Great Lakes UK Limited
Great Wolf Lodge, Chesterton, Bicester

Non Material Amendment (S.96a) Application
Design Changes

March 2023

2.2 Scheme Changes Update Proposed Amended Scheme - First Floor

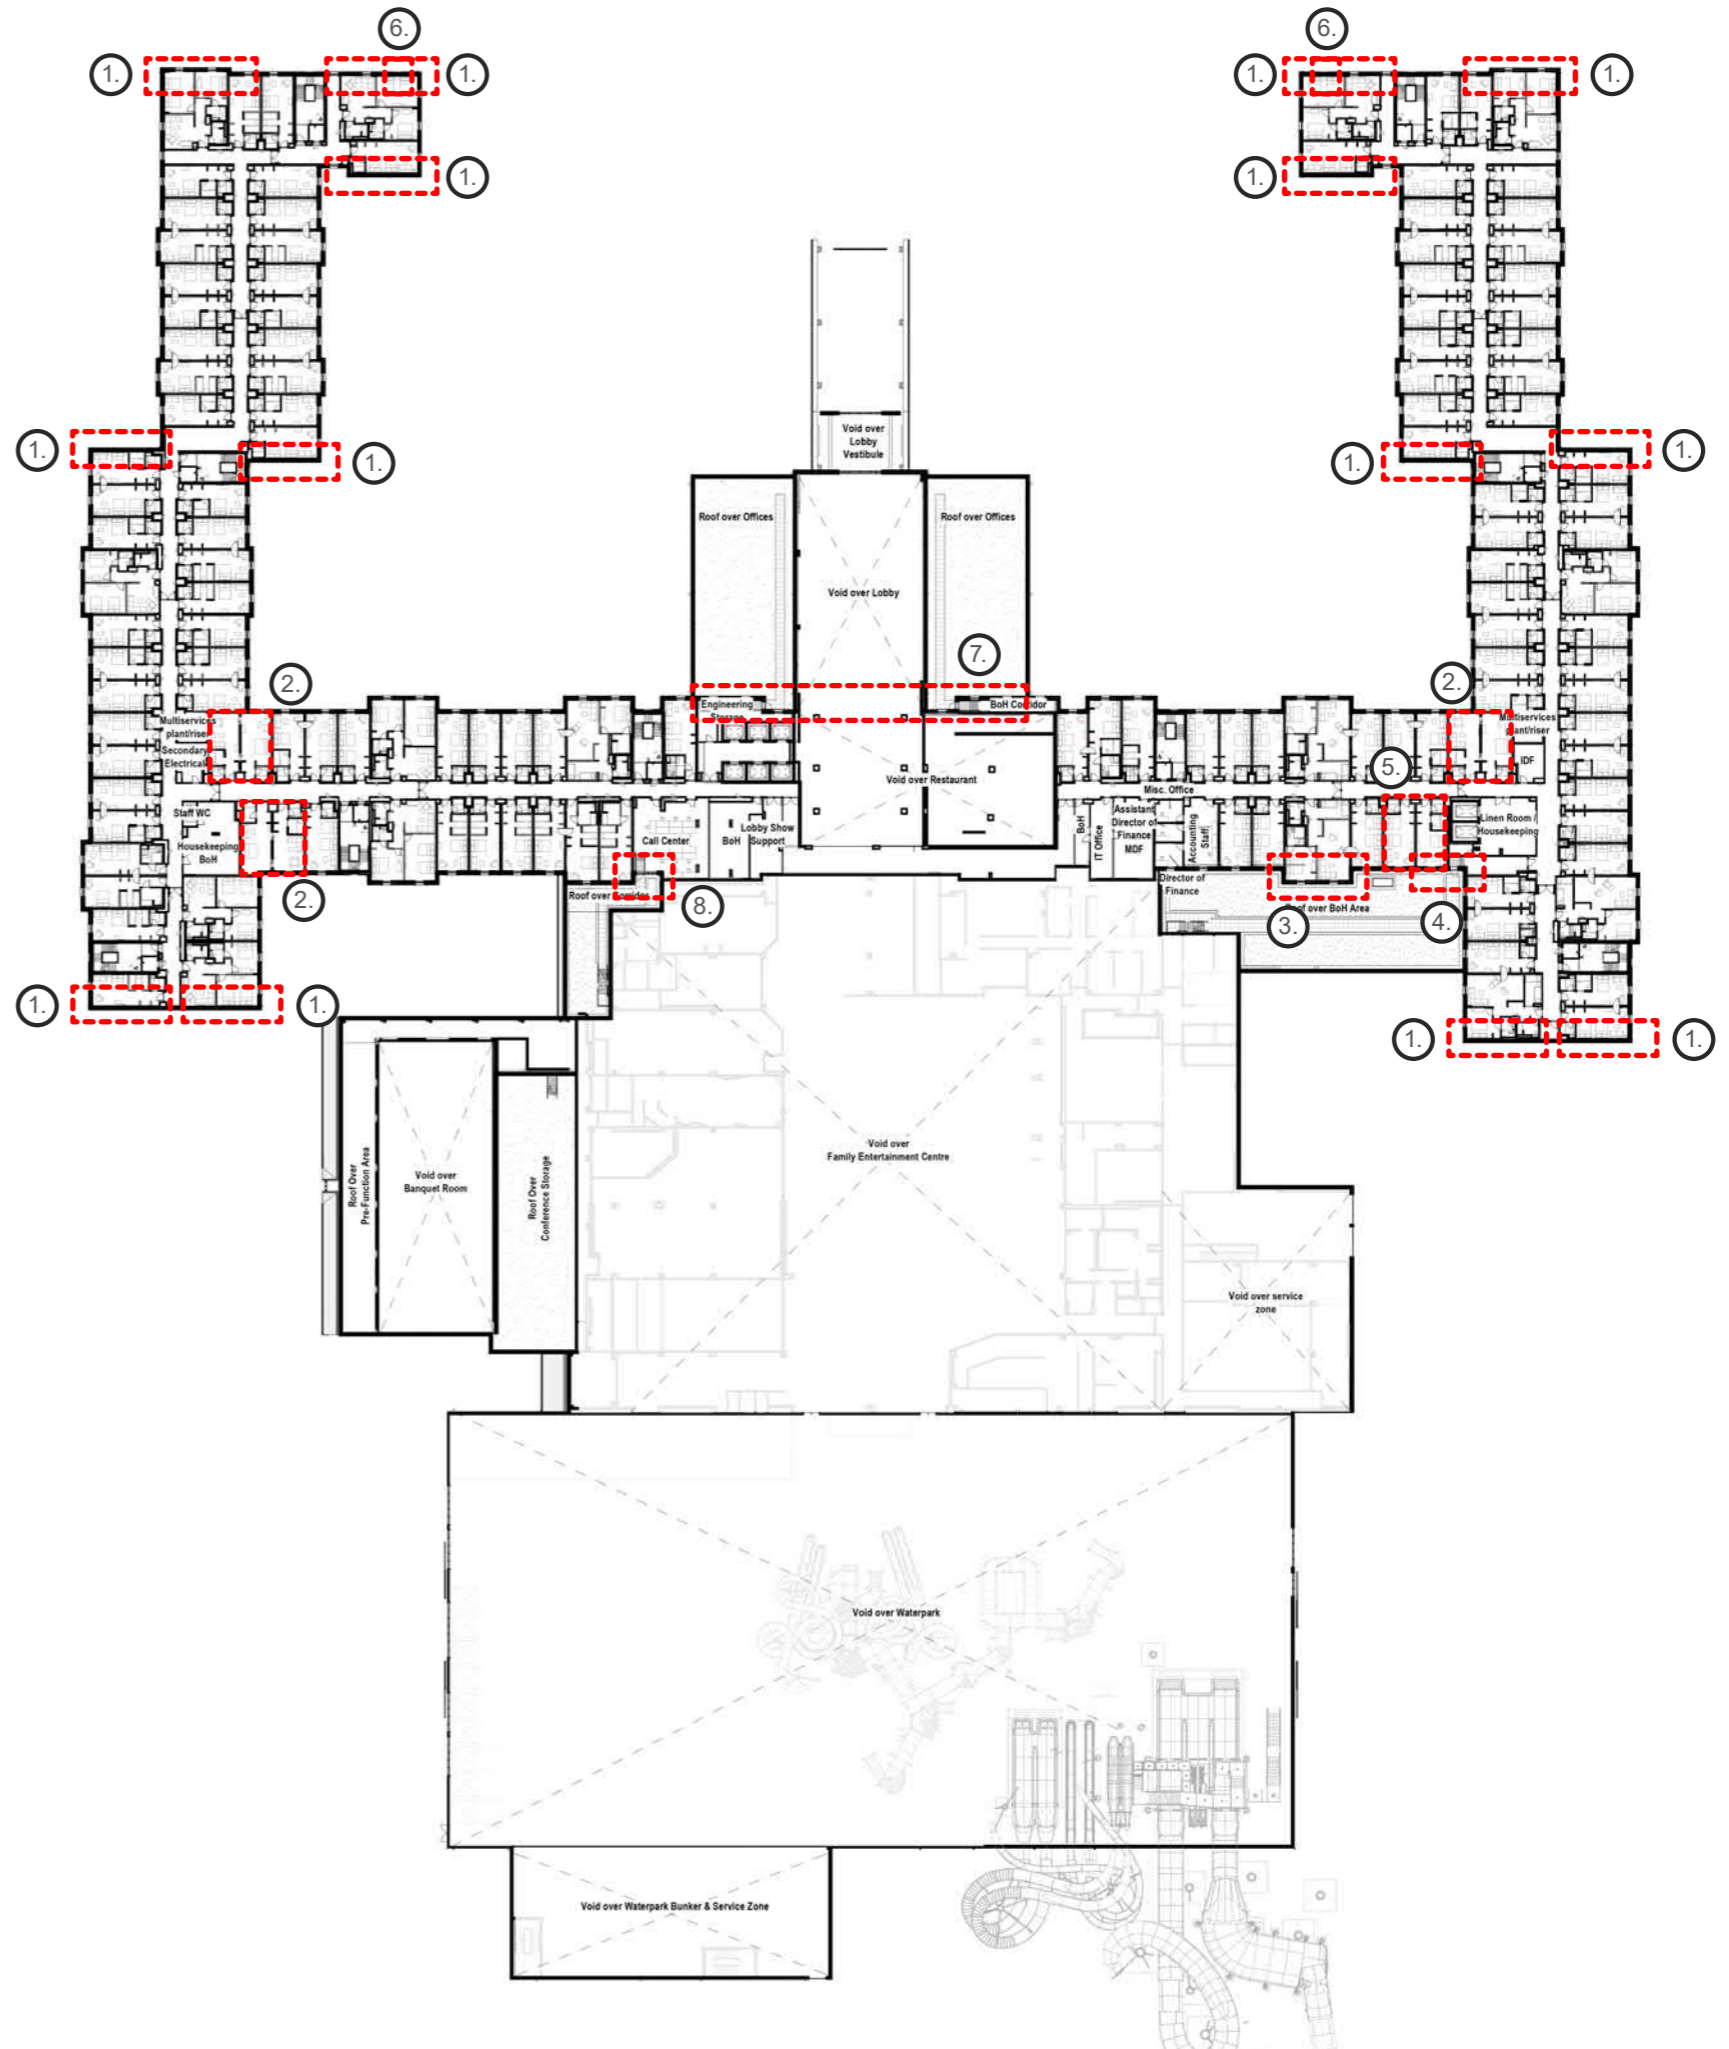
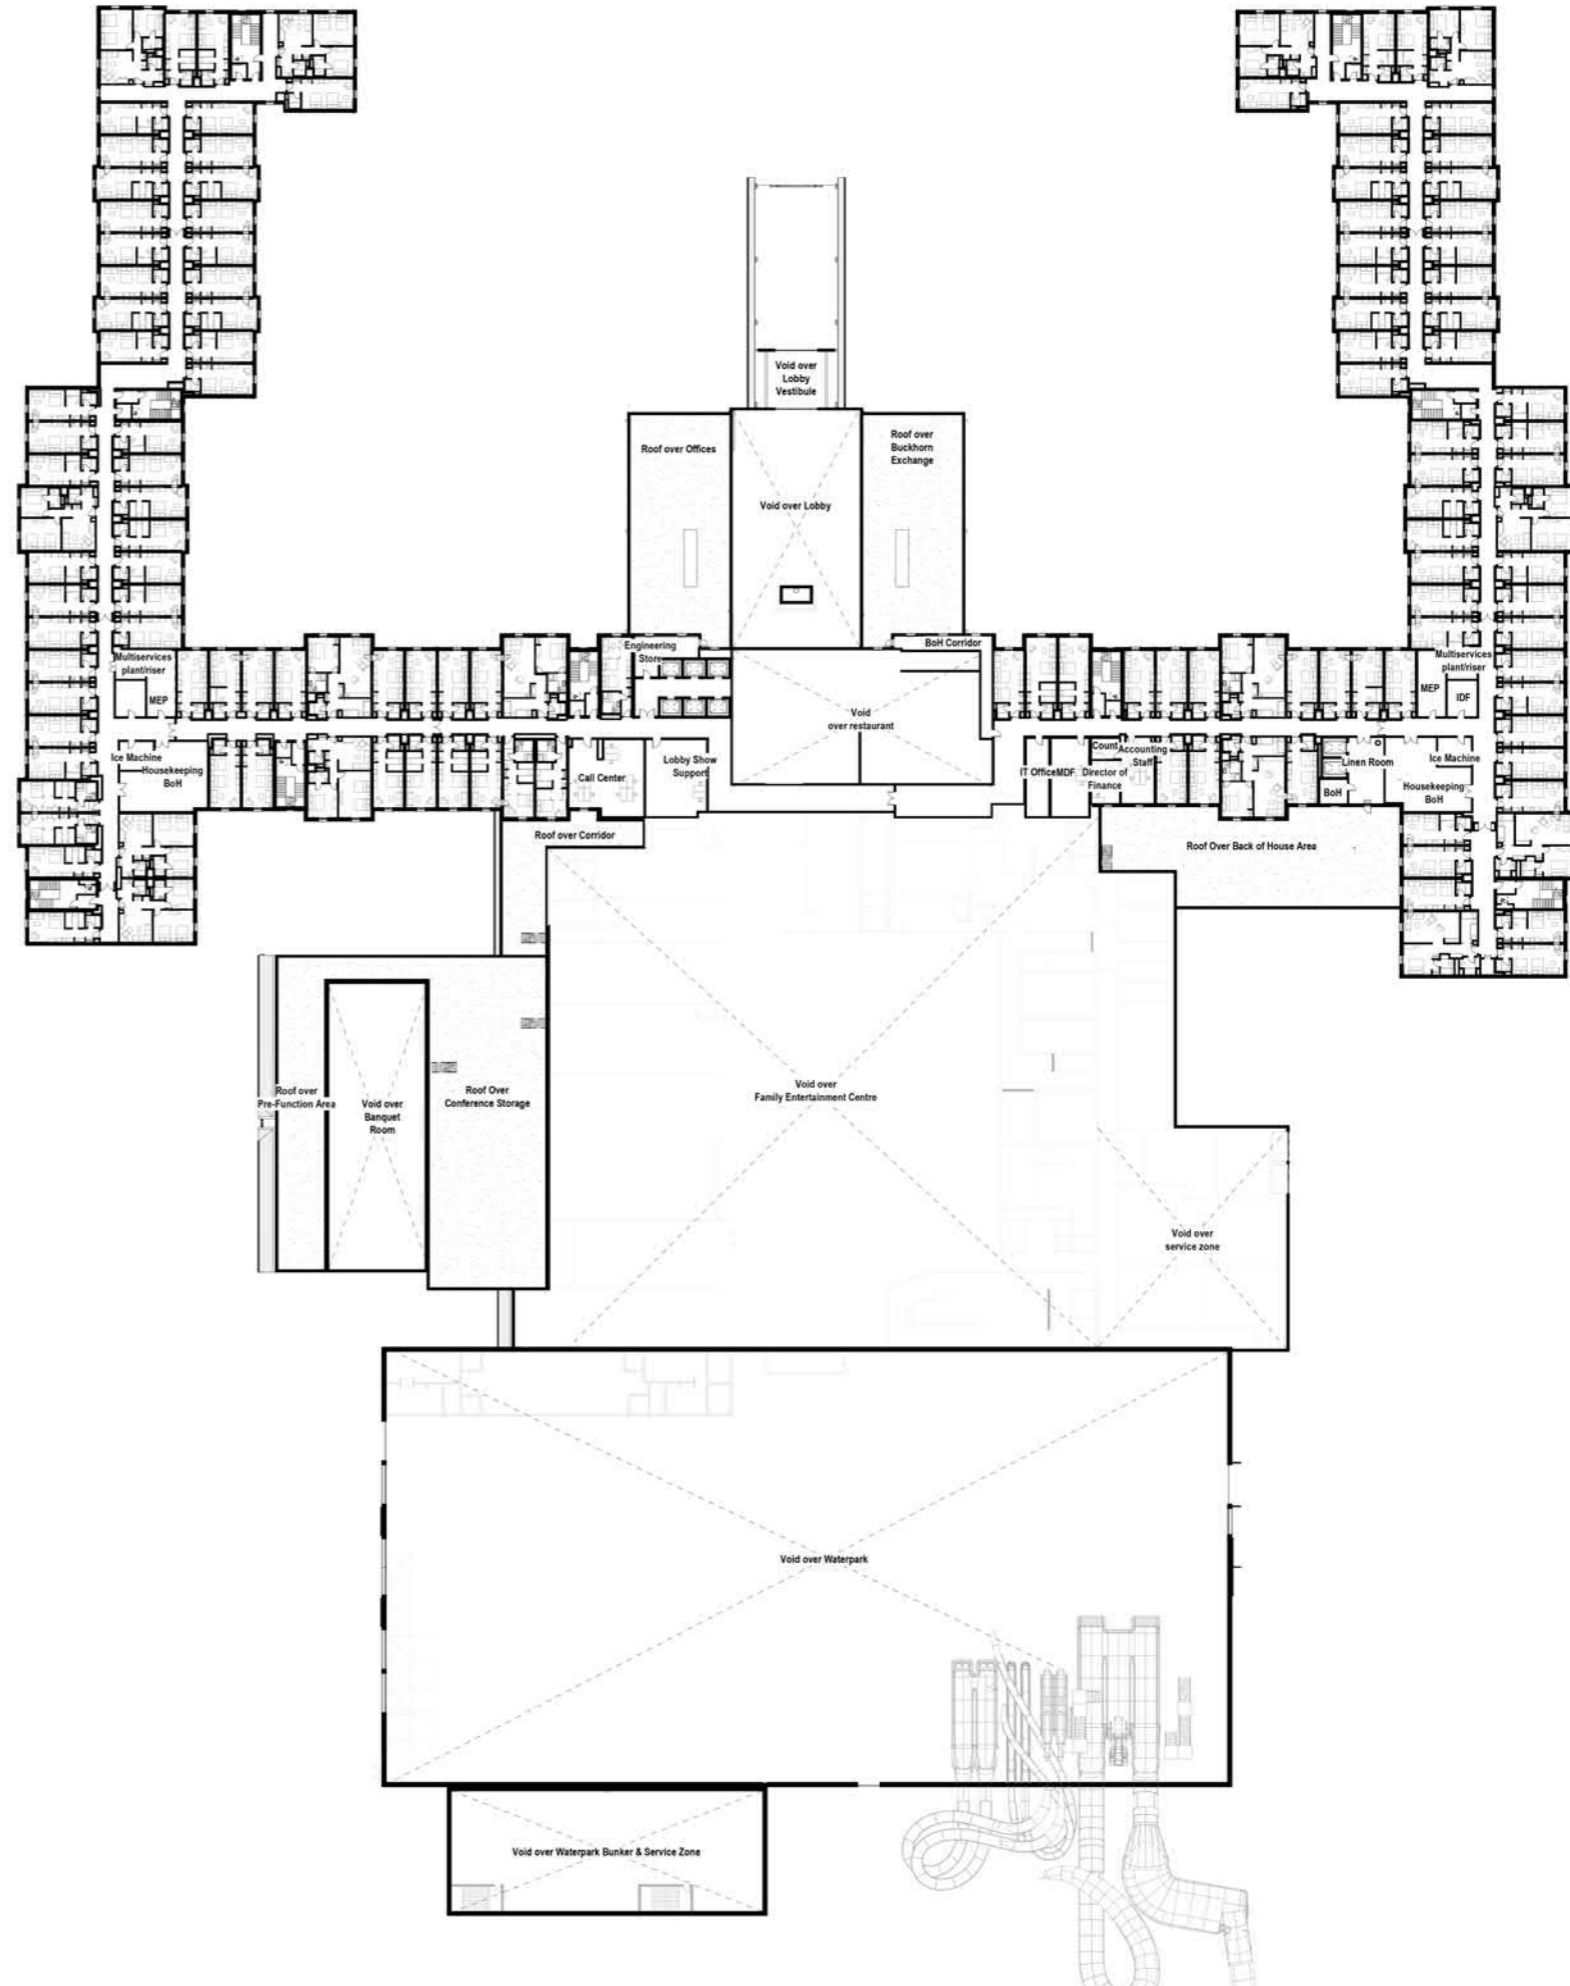
- ① Facades pushed out to allow columns not to protrude into guestrooms.
- ② Corner guestrooms changed to new enlarged types on every floor. 12 no. total rooms affected but no increase in room numbers with this change and no facade changes.
- ③ Façade wall moved down 100mm to align with equivalent wall on left hand side.
- ④ 2x Windows added on levels 1-3 and door added on right on level 1 to provide safer roof access
- ⑤ 6 No. total additional keys added where shown on levels 1-3. Total guestroom count to be 504.
- ⑥ Replace windows in corner rooms (where there were two windows in room) to recessed reveal detail.
- ⑦ Window types on the east side updated to match those on west side.
- ⑧ Additional means of escape off the roof via the 1st floor offices.
